ATTACHMENT 2

OCONEE 1, CYCLE 4

PROPOSED TECHNICAL SPECIFICATION CHANGES

Figure 3.5.2-1A1

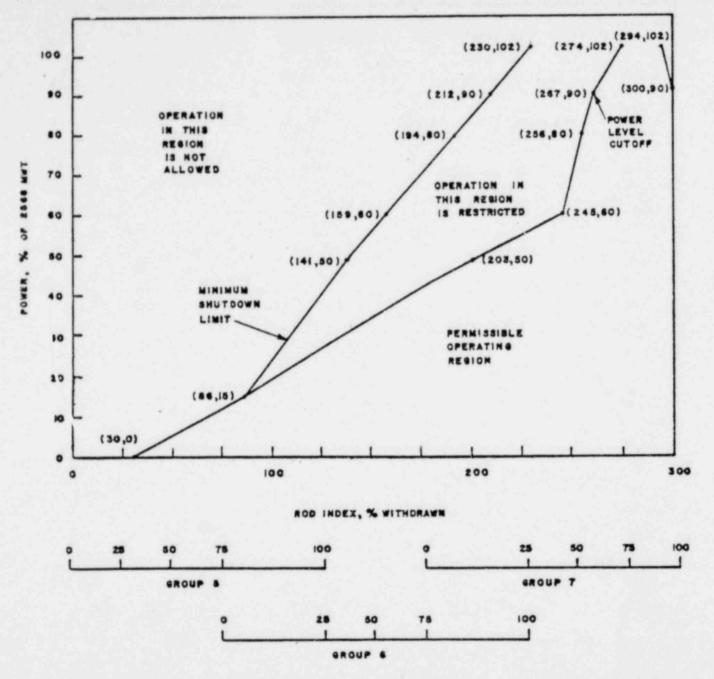
OCONEE 1 CYCLE 4 ROD POSITION LIMITS FOR FOUR PUMP OPERATION FROM 0 TO 100 (+10) EFPD

- c. Position limits are specified for regulating and axial power shaping control rods. Except for physics tests or exercising control rods, the regulating control rod insertion/withdrawal limits are specified on figures 3.5.2-1A1, (Unit 1); 3.5.2-1B1, 3.5.2-1B2 and 3.5.2-1B3 (Unit 2); 3.5.2-1C1, 3.5.2-1C2 and 3.5.2-1C3 (Unit 3) for four pump operation, and on figures 3.5.2-2A1, (Unit 1); 3.5.2-2B1, 3.5.2-2B2 and 3.5.2-2B3 (Unit 2); 3.5.2-2C1, 3.5.2-2C2 and 3.5.2-2C3 (Unit 3) for two or three

- d. Except for physics tests, power shall not be increased above the power level cutoff as shown on Figures 3.5.2-1A1, (Unit 1), 3.5.2-1B1, 3.5.2-1B2, and 3.5.2-1B3 (Unit 2), and 3.5.2-1C1, 3.5.2-1C2, 3.5.2-1C3 (Unit 3), unless the following requirements are met.

OCONEE 1 CYCLE 4 ROD POSITION LIMITS FOR TWO AND THREE PUMP OPERATION FROM 0 TO 100 (*10) EFPD OCONEE NUCLEAR STATION

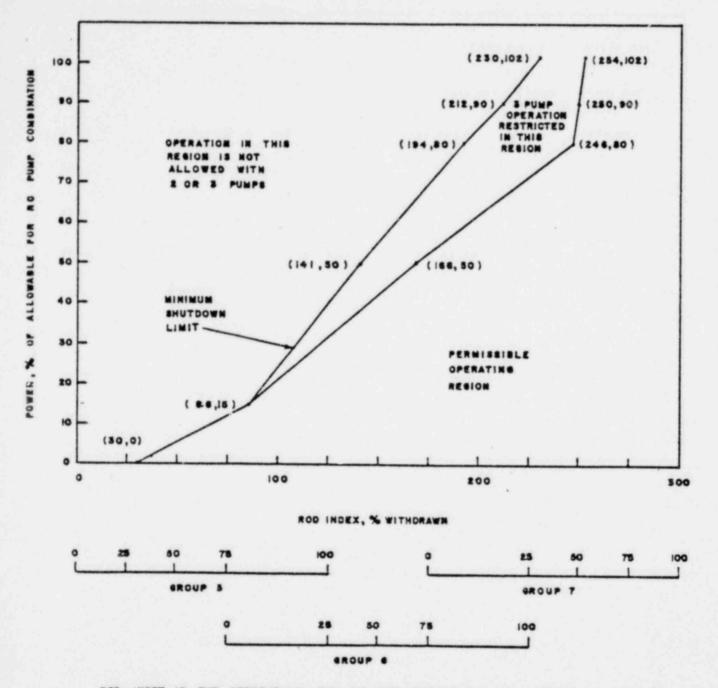
ROD INDEX IS THE PERCENTAGE SUM OF THE WITHDRAWAL OF GROUPS 5, 6 AND 7
